**ENVIRONMENTAL COMMISSION RECOMMENDATION 20240515-004**

Subject: Sunfield PUD Amendment #1, C814-2014-0083.01

C814-2014-0083.01 (PUD Amendment)

Environmental Exhibit

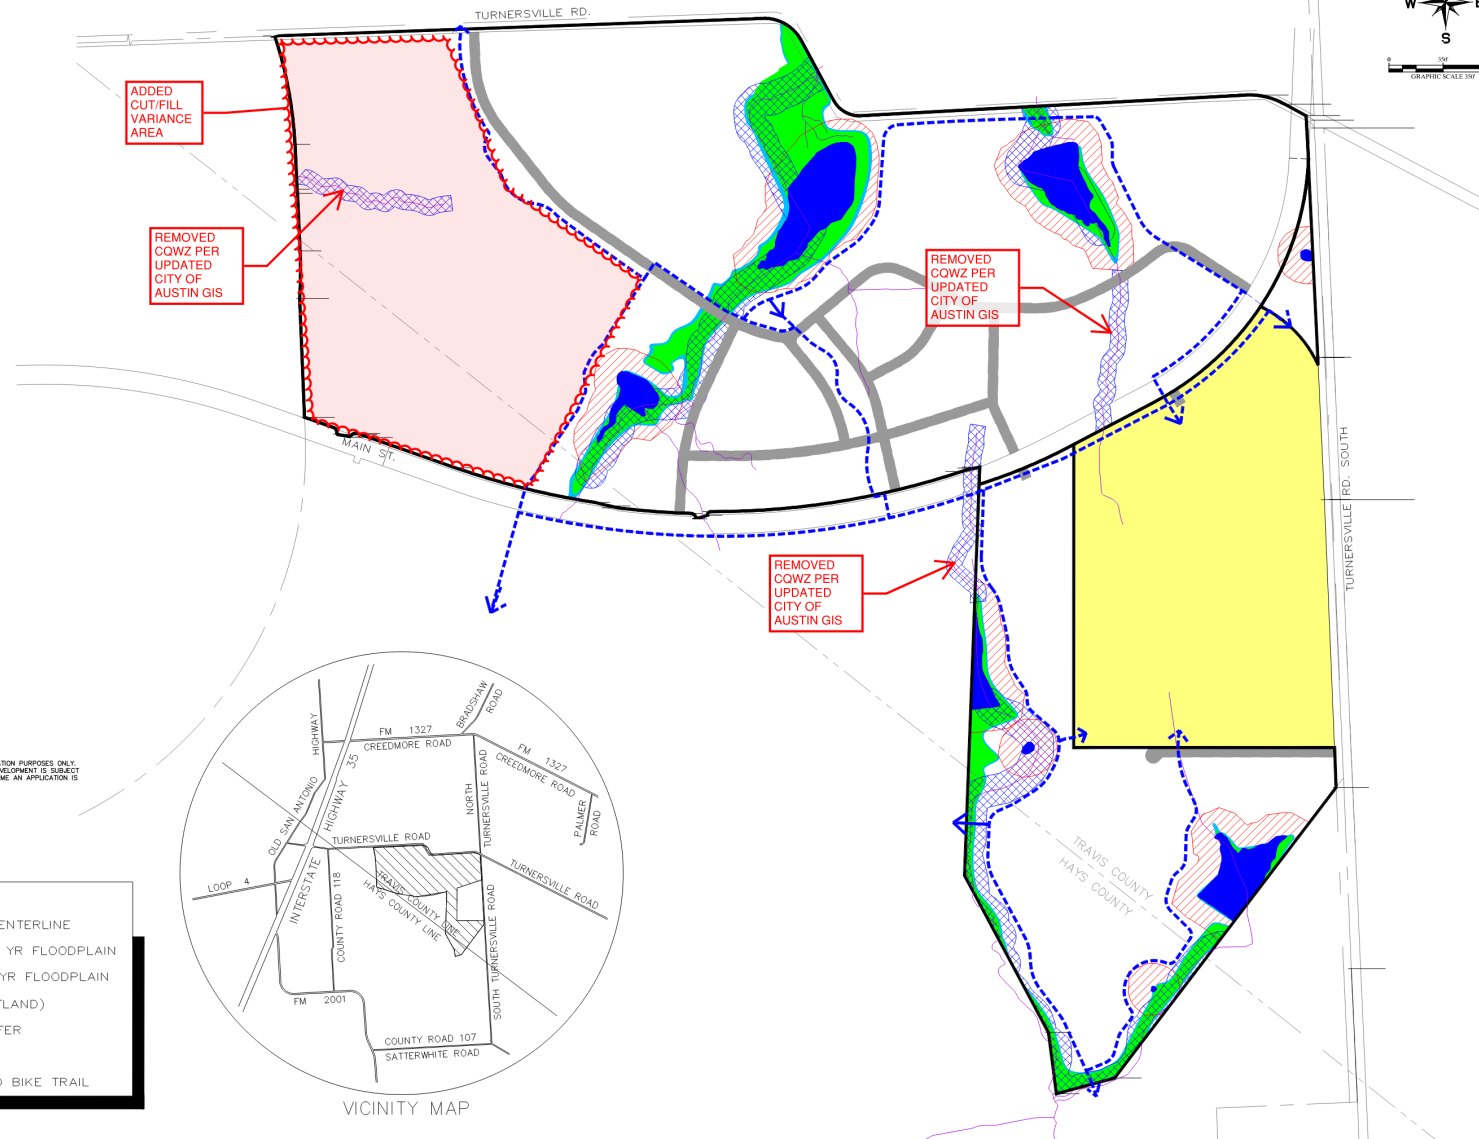
- b. Section 25-8-342 modified to allow fill up to 20 ft
 - c. Modification of protected CWQZs as shown in Exhibit F
 - d. Modification to Land Use Plan to permit a light industrial/warehouse use on approximately 91 acres.

- 1. Section 25-8-341 modified to allow cut to exceed 4 feet (up to 20 ft) to allow for the construction within the area shown on Environmental Exhibit**
- 2. Section 25-8-342 modified to allow fill to exceed 4 feet (up to 20 ft) to allow for the construction within the area shown on Environmental Exhibit**
- 3. Modify Land use from Residential to Commercial/Industrial. Increase in allowable IC from 57.87% to 62.33% (21.484 acres)**
- 4. Remove +1000 linear ft of previously unprotected creek**
